LOT GRADING REVIEW

LECCO RIDGE DEVELOPMENTS INC.

LOT No. 37

PART OF LOT 6 CONCESSION 2, NEW SURVEY (GEOGRAPHIC TOWNSHIP OF TRAFALGAR) REGIONAL MUNICIPALITY OF HALTON 20M-1184 TOWN OF MILTON

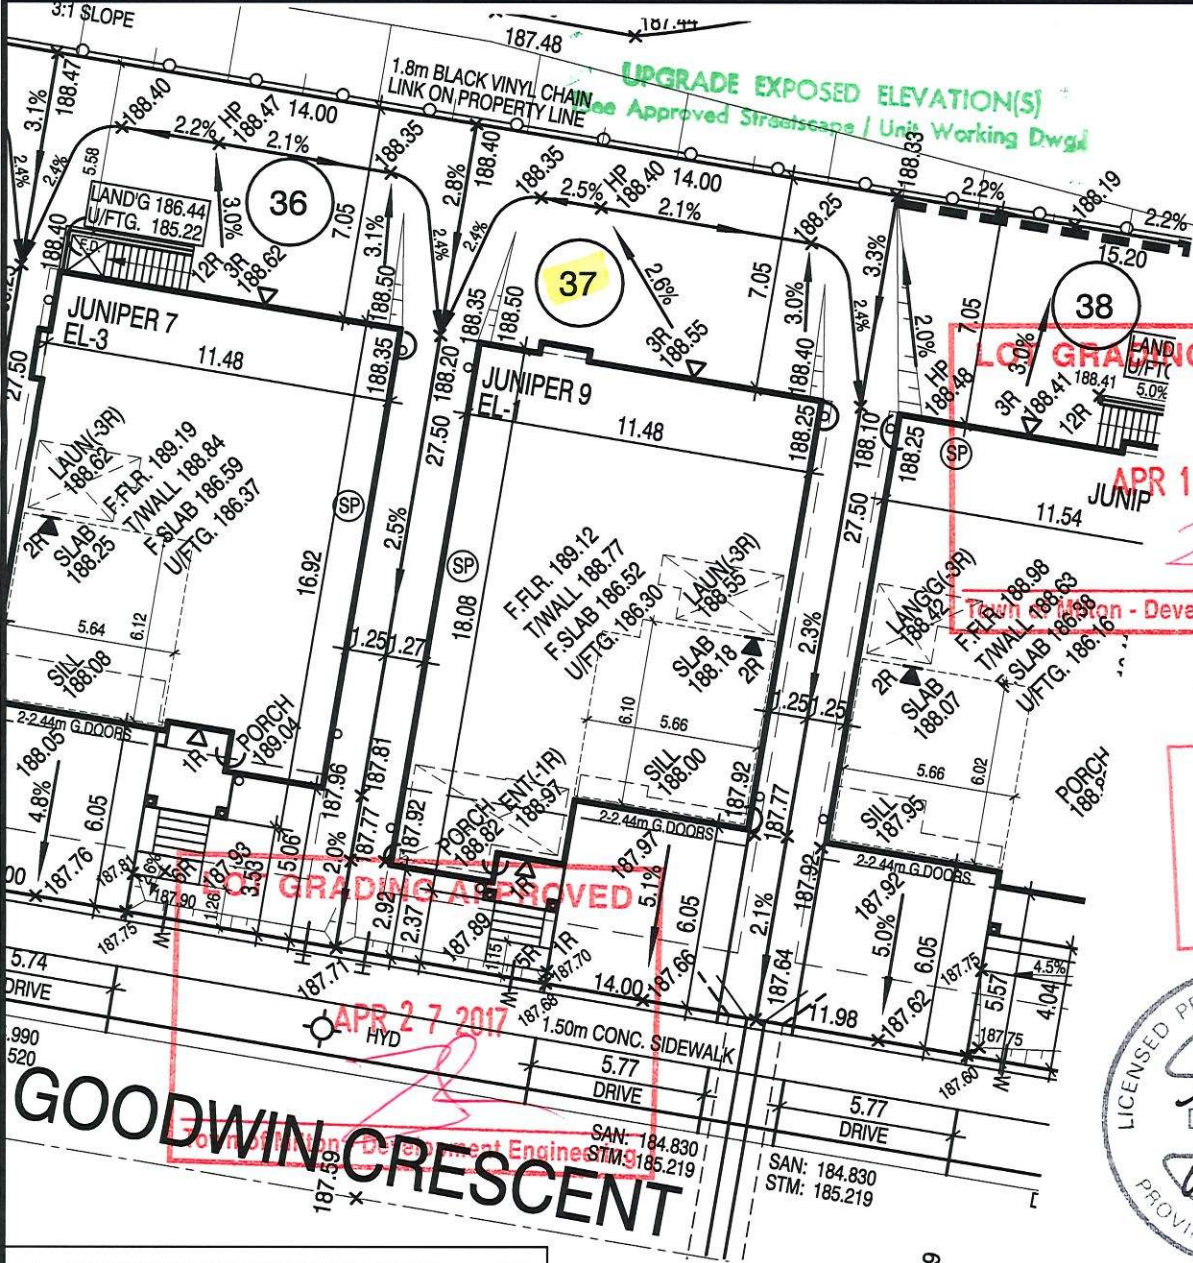
Guard/Handrail as per 9.8.

Backfill height as per 9.15.

Siting to be read in conjunction with reviewed main model drawings

45 MINUTE RATED WALL WITH SIDE YARD < 1.2m

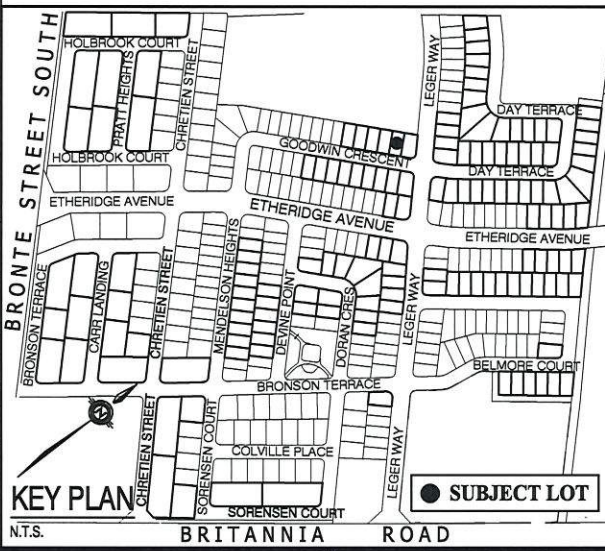
SUMP PUMP TO BE CONNECTED TO STORM SEWER.

45 MINUTE RATED WALL WITH SIDE YARD < 1.2m
